PLAN AND ZONING COMMISSION MEETING

CITY OF DAVENPORT, IOWA

Case F21-08: Request of S.J. Russell, L.C. on behalf of Sophie Foster Revocable Trust for a Final Plat of Birchwood South First Addition for a 6-lot subdivision on 17.92 acres located at 4607 East 53rd Street. [Ward 6]

Re: PRJ-2511

PRELIMINARY PLAT

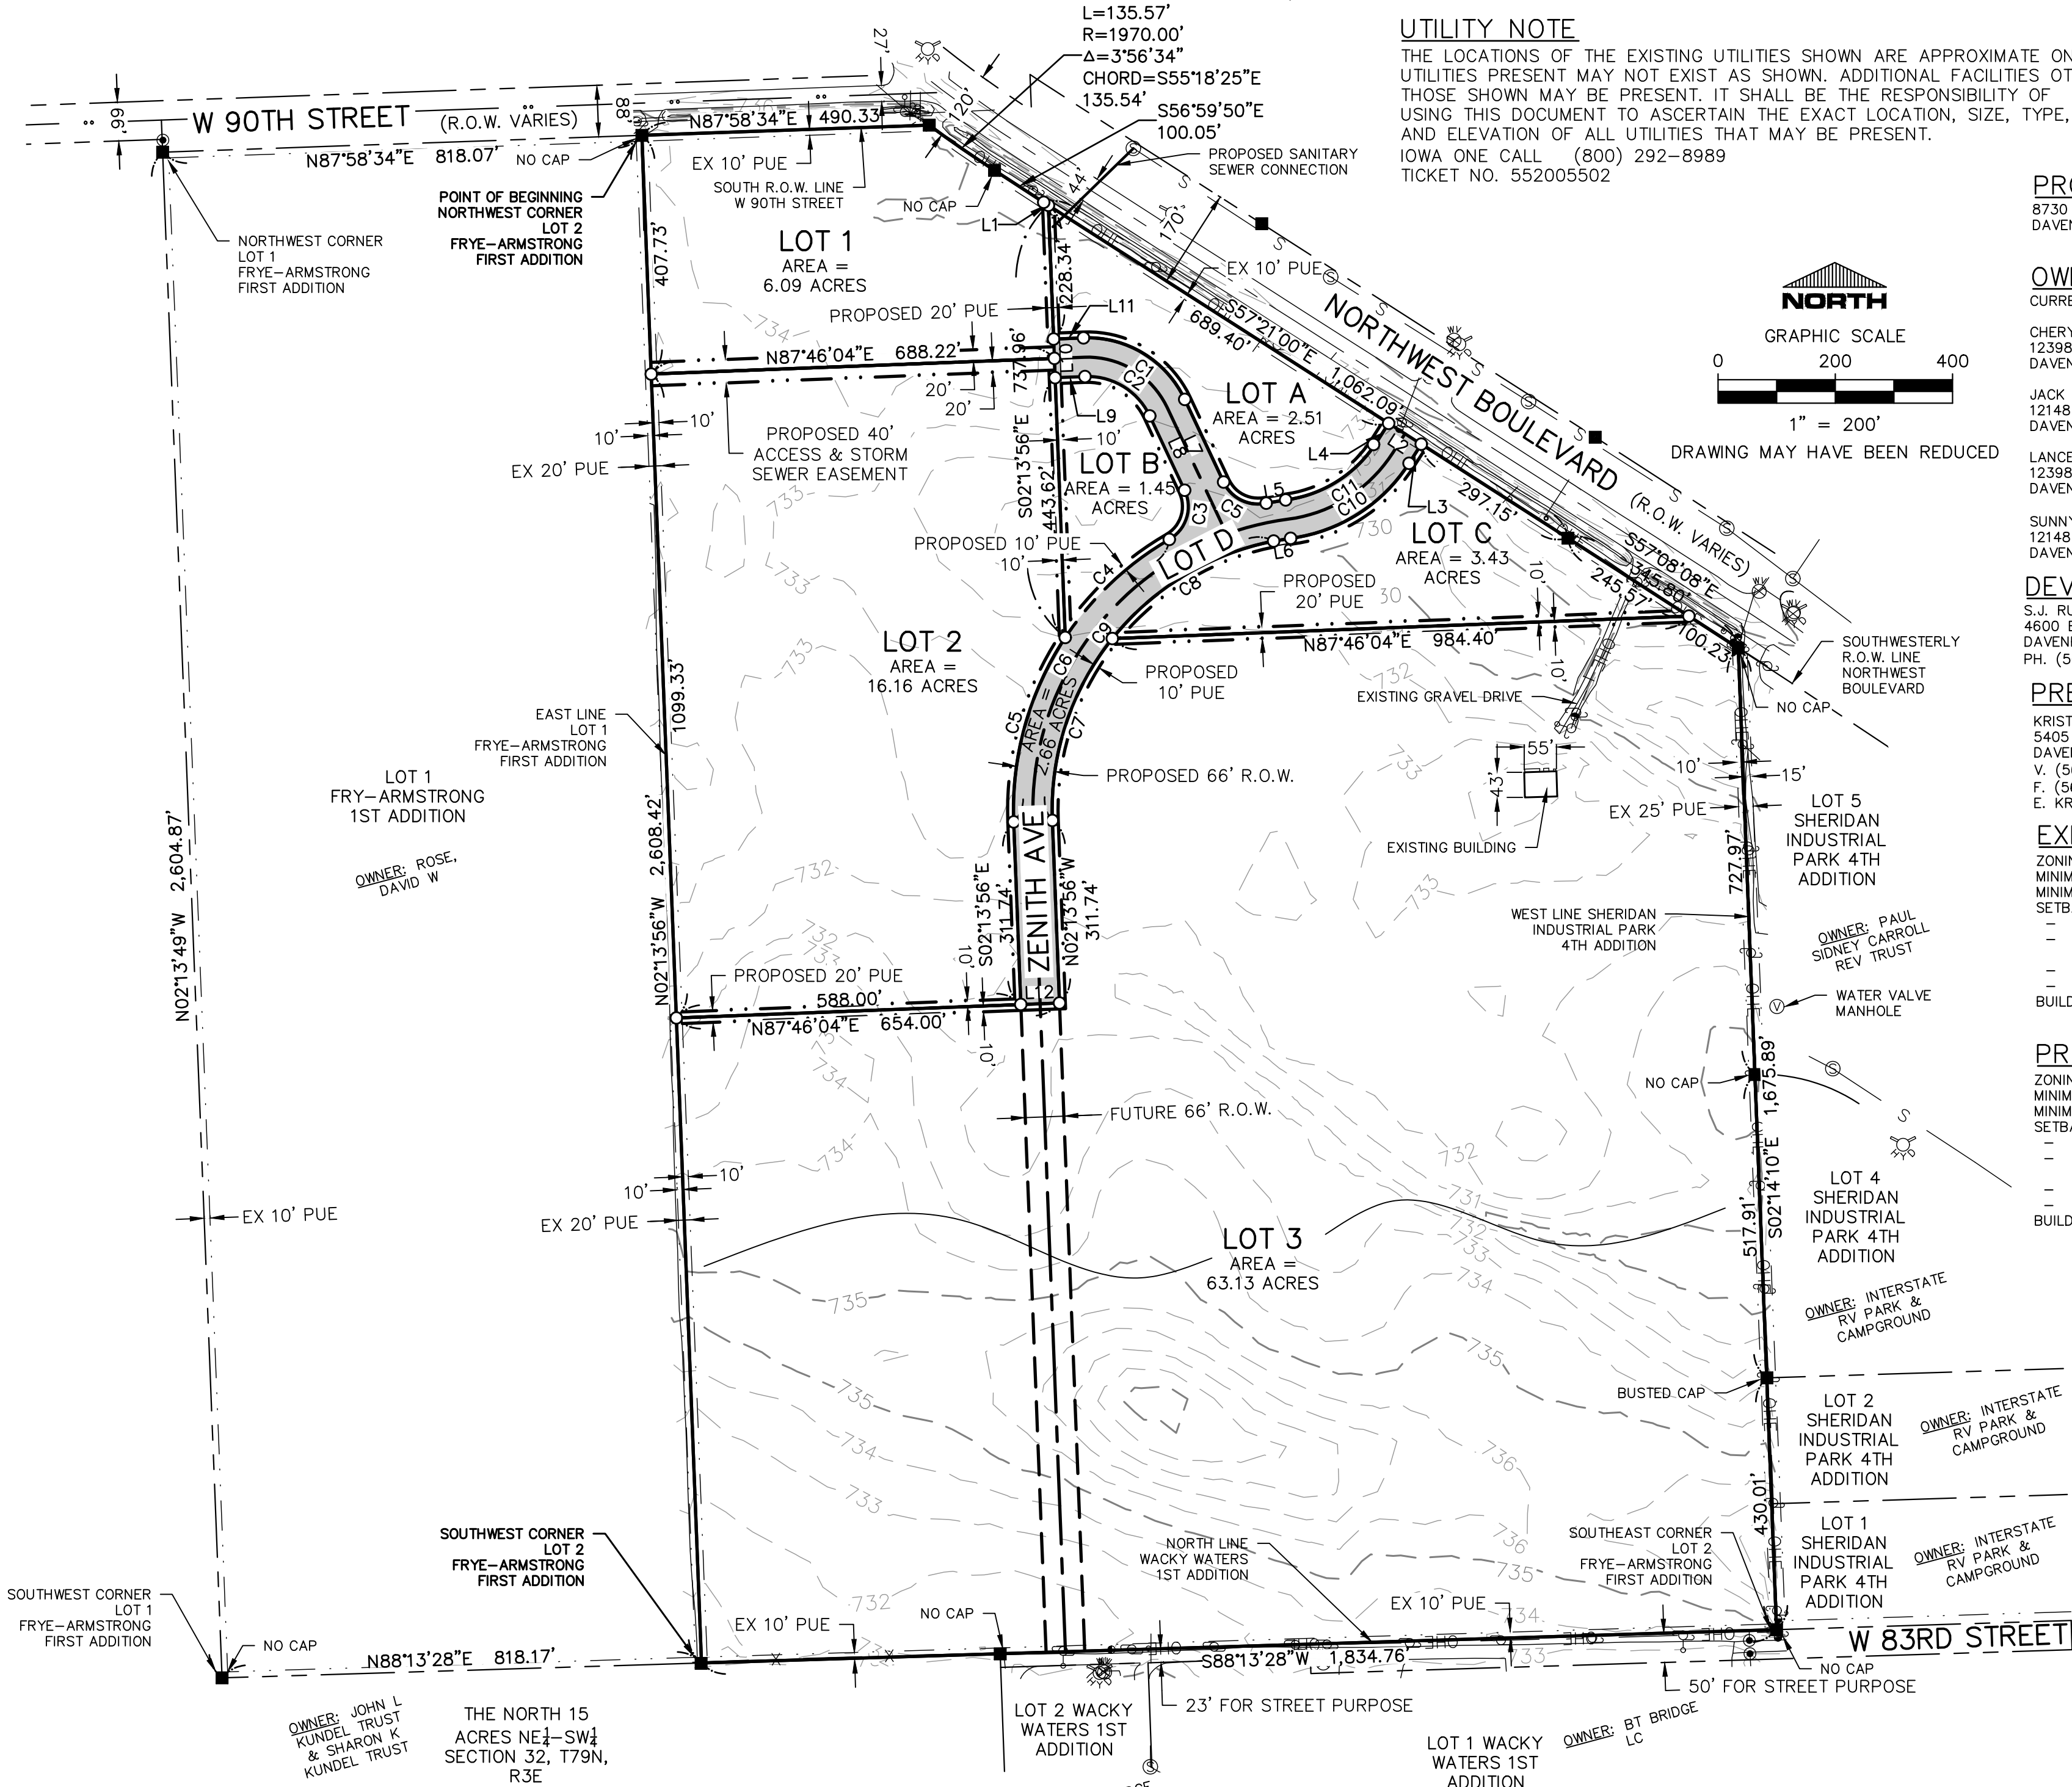
1. An additional 20 feet of Utility Easement shall be added to the existing 10 foot easement along the south lot line.
2. All sewer easements shall be either 15 feet wide or twice the depth of the sewer, whichever is greater.

5. Standard Plat Notes shall be added.
6. Corporate limits shall be shown on the plat.
7. Lot three shall not have any direct access to Northwest Boulevard.

8. Additional storm and sanitary sewer easements shall be required based on preliminary engineering of conceptual plans including service drainage of the property to the west.

9. Provide 30 feet of right-of-way radii at the intersection of Northwest Boulevard & Zenith Avenue.
10. Lots A, B, and C shall be labeled as outlots and shall be shown with stormwater detention easements.
